# PART 70 OPERATING PERMIT OFFICE OF AIR MANAGEMENT

# Rieter Automotive North America, Inc. 101 West Oakley Avenue Lowell, Indiana 46356-2206

Operation Permit No.: T089-6629-00013		
Issued by: Janet G. McCabe, Assistant Commissioner Office of Air Management	Issuance Date:

On November 4, 1998, Mary Ann Saggese, attorney for Rieter Automotive North America submitted comments on the proposed Part 70 Operating Permit. The summary of the comments is as follows (strikeout added to show what was deleted and **bold** added to show what was added):

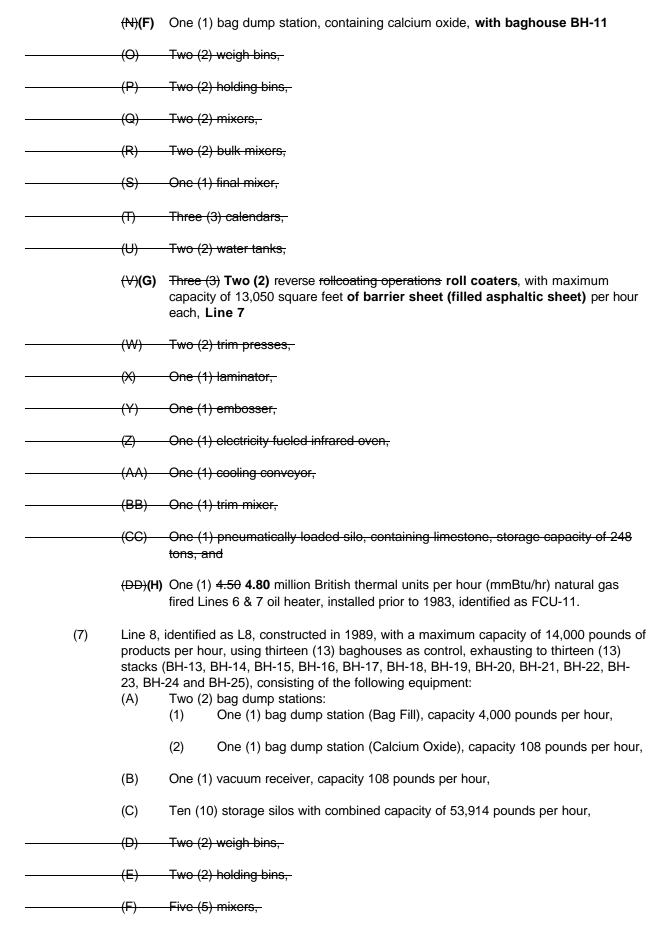
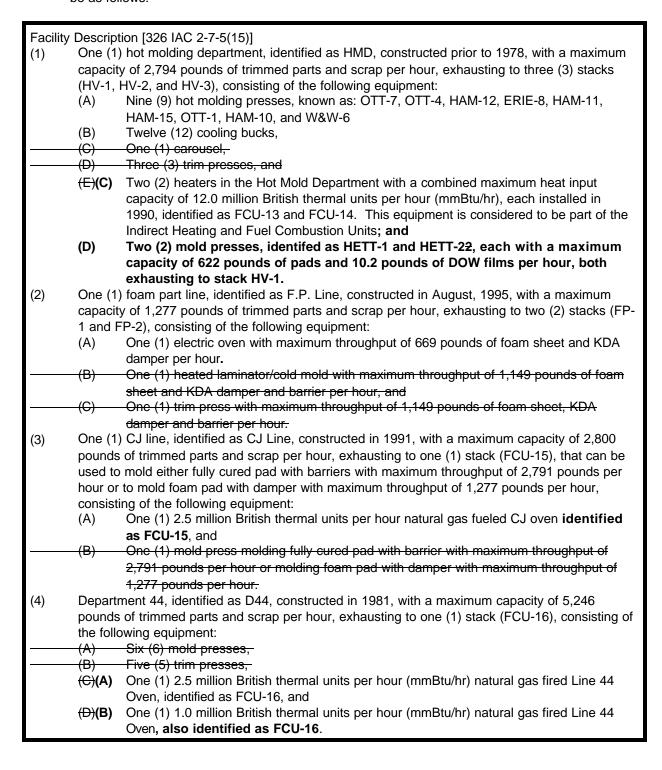
The following are changes requested in the draft Part 70 Operating Permit to correct errors in the number of pieces of equipment listed in the respective departments, to delete equipment listed that is not an emission unit or pollution control device or to record changes pursuant to construction permits/registrations/exemptions issued since the application was filed on September 20, 1996:

A.2(1)(C)&(D)	Delete; not emission units.
A.2(2)(B)&(C)	Delete; not emission units.
A.2(3)(A)	One (1) 2.5 million British thermal units per hour natural gas fueled CJ oven identified as FCU-15.
A.2(3)(B)	Delete; not emission units.
A.2(4)(A)&(B)	Delete; not emission units.
A.2(4)(D)	One (1) 1.0 million British thermal units per hour (mmBtu/hr) natural gas fired Line 44 Oven, also identified as FCU-16.
A.2(5)	Line 2, identified as L2, constructed in the 1970s, with a maximum capacity of 3,744 pounds of saturated felt parts and trim scrap per hour, exhausting to one (1) stack (SV-1), consisting of the following equipment:
A.2(5)(B)	One (1) coater #1 using flexacryl with maximum capacity of 15,900 square feet of damper per hour and 63.6 gallons of flexacryl per hour,
A.2(5)(C)	One (1) coater #2 using fuller glue with maximum capacity of 15,900 square feet of damper per hour and 31.8 gallons of fuller glue per hour,

A.2(5)(B)&(C)	Changes are required because there is only one line but two (2) coaters.
A.2(5)(E)	Delete; this emission unit decommissioned; IDEM notified 8/1/97.
A.2(6)	This covers two (2) production lines #6 & #7. All the equipment on these two lines were combined by IDEM in the permits so the following changes should be made for clarification purposes.
A.2(6)(A)	Delete; not emission units.
A.2(6)(B)	Delete; not an emission unit.
A.2(6)(D)	One (1) reverse roll coater with maximum capacity of 21,750 square feet of barrier and damper sheet (filled asphaltic sheet) per hour, Line 6,
A.2(6)(E)	One (1) bag dump station with baghouse BH-12,
A.2(6)(F)	Nine (9) pneumatically loaded silos (#9 through #17) with a combined capacity of 46,945 pounds per hour,

#### **Response to Comment 2:**

This stationary source consists of the following emission units and pollution control devices:

- One (1) hot molding department, identified as HMD, constructed prior to 1978, with a maximum capacity of 2,794 pounds of trimmed parts and scrap per hour, exhausting to three (3) stacks (HV-1, HV-2, and HV-3), consisting of the following equipment:
  - (A) Nine (9) hot molding presses, known as: OTT-7, OTT-4, HAM-12, ERIE-8, HAM-11, HAM-15, OTT-1, HAM-10, and W&W-6
  - (B) Twelve (12) cooling bucks,

Condition D.5.13(b)

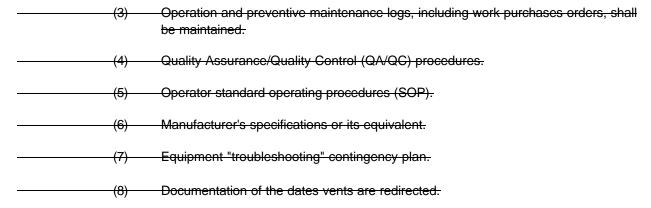
As shown in Comment #32 to Condition D.5.10, imposition of daily monitoring of baghouse pressure drops is unnecessary and burdensome. Likewise, record keeping that supports this condition is equally invalid. Rieter Automotive requests that this condition be deleted in its entirety.

# Response to Comment 34:
